工程指示 / 要求簡箋(E.I.)

工程指示編號：EI / 2852 / 20 修改版次：
 工程編號 : J - 852 工程名稱 : 亞皆老街中電
 工程項目 : 後加工程報價 - Canopy 頂百葉 STONE CLADDING 改為鋁板
 收件人 : 楠哥 發件人 : Bessie Lau 日期 : 17/12/2020

Re : Design, Supply & Installation of Aluminium Window & Cladding, Curtain Wall, Glass Wall, Louvers and Glass Balustrade Nominated Sub-Contract at K.I.L. 6038RP, K.I.L.6037RP, K.I.L. 6036RP, K.I.L. 6035RP & K.I.L. 6005, Nos. 139-147 Argyle Street, Kowloon.
Query on Design Intent of Louver above Canopy at LG2/F (RFI041)

DRAWING TITLE:
KEY PLAN FOR LG2/F
GLASS BALUSTRADE AT CLOCK TOWER

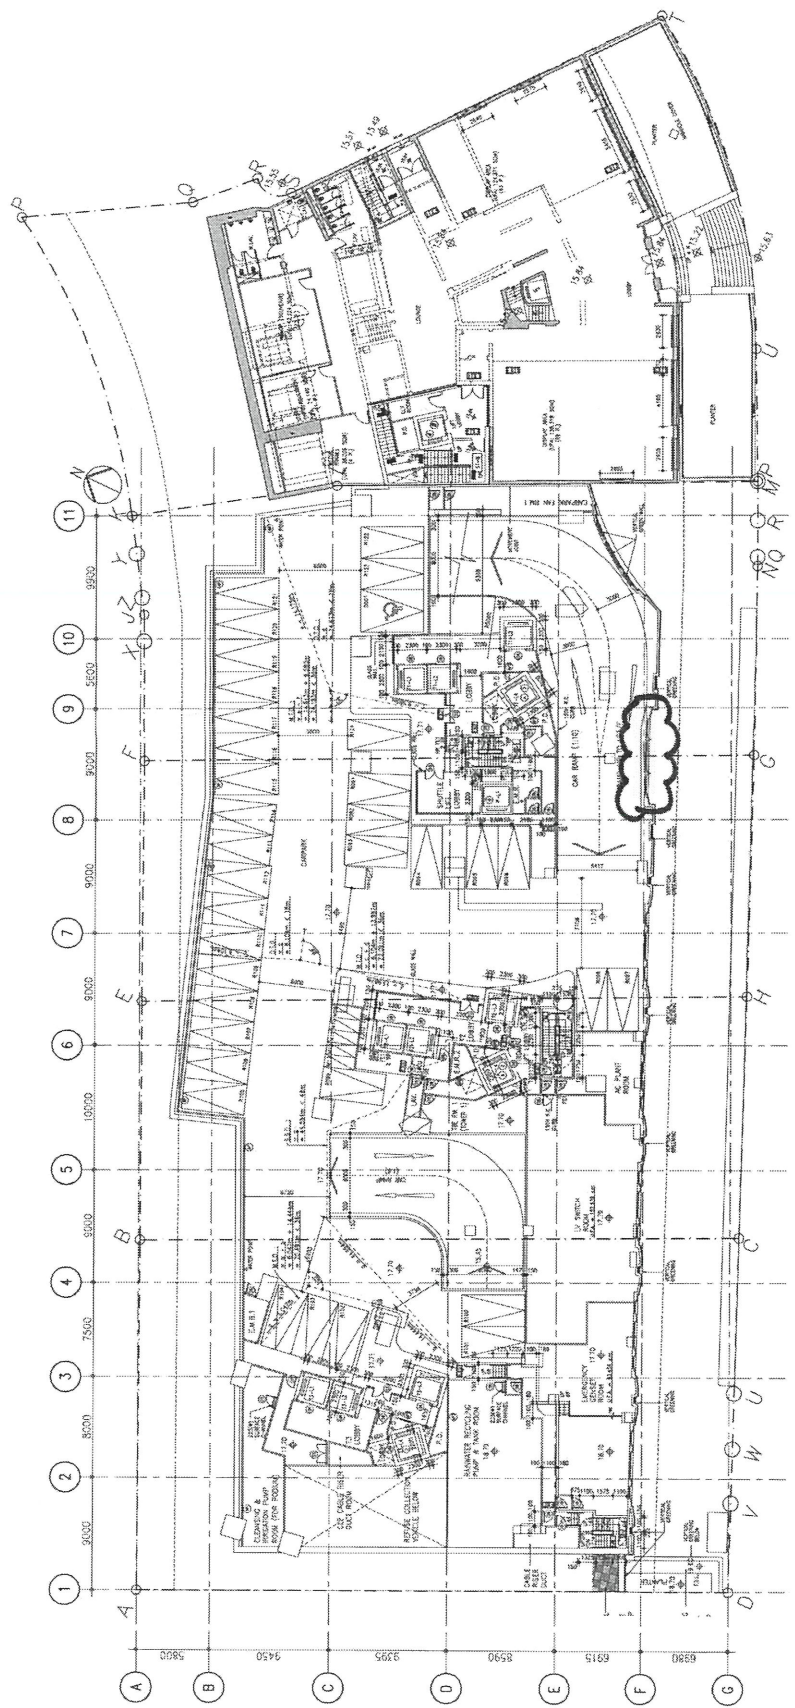
Regarding aluminium louver above canopy at LG2/F, limestone cladding beside aluminium louver should be installed by stone NSC with reference to the attached tender drawing. However, according to our discussion with AGC and Meinhardt during TQ meeting, R.C. structure doesn't exist and limestone cladding should be replaced by aluminium cladding with steel frame. Please provide design intent for our shop drawing preparation.

limestone cladding changes into aluminium cladding

Aluminium Louver above canopy

Canopy 頂百葉與百葉之間本來做 STONE CLADDING, 現改為做鐵通加鋁板, 煩請按此報價
(則師開會時通知由我司做, 會出信追 AI)
AI 後補
